**FACTS AND FINDINGS
COLUMBIA RIVER GORGE COMMISSION STAFF REPORT**

FILE NO.: C17-0004

REQUEST: Application to use an existing surface mine site for disposal of natural materials removed during road maintenance activities. Rock and earth will be deposited to restore surface elevations to the original site conditions over time and 60 ponderosa pine trees will be planted.

RESTORATION PLAN

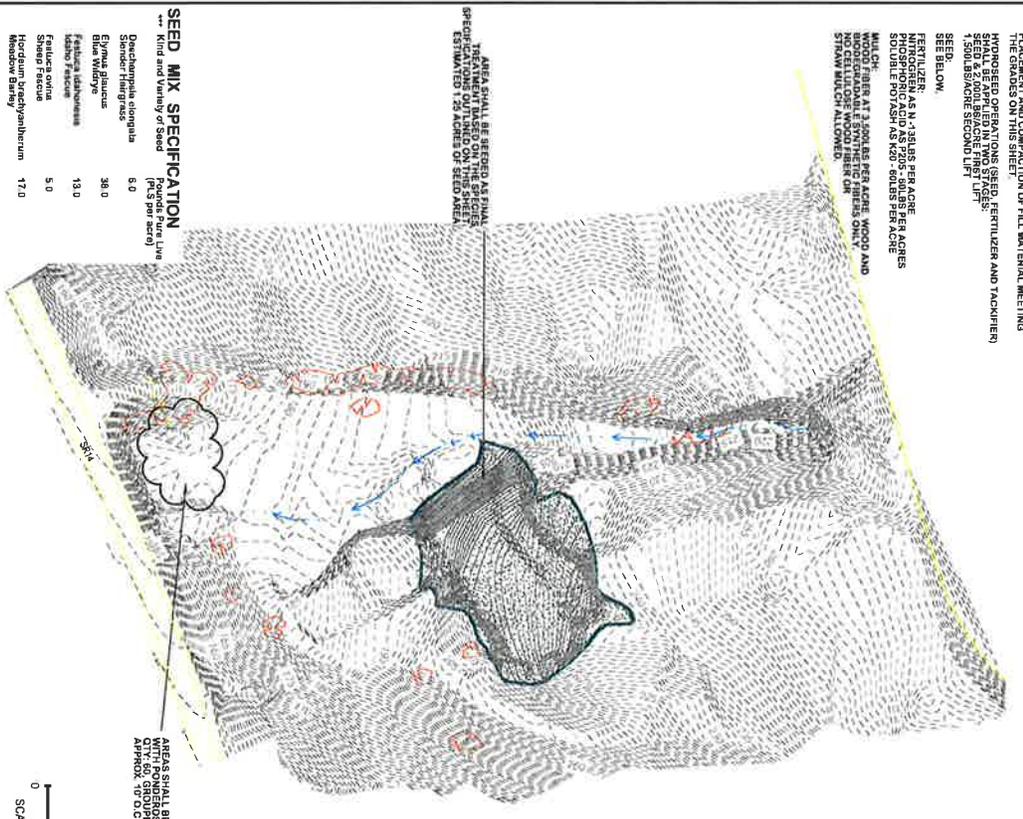
The applicant shall plant 60 conifer trees as indicated on the restoration plan. Trees shall be native species, such as ponderosa pine, planted in a natural pattern of tree groups and spacing. In accordance with Commission Rule 350-100-530(2)(j), the applicant shall install the trees as soon as practicable and prior to project completion. Following restoration of surface elevations, disturbed areas shall be seeded in accordance with the restoration plan. The applicant is responsible for the proper maintenance and survival of planted vegetation, and replacement of such vegetation that does not survive.

The applicant provided a grading and restoration plan. The disposal site includes approximately 1.25 acres, less than 15 percent of the subject parcels. Following restoration of surface elevations, the 1.25-acre area will be hydroseeded in accordance with the restoration plan.
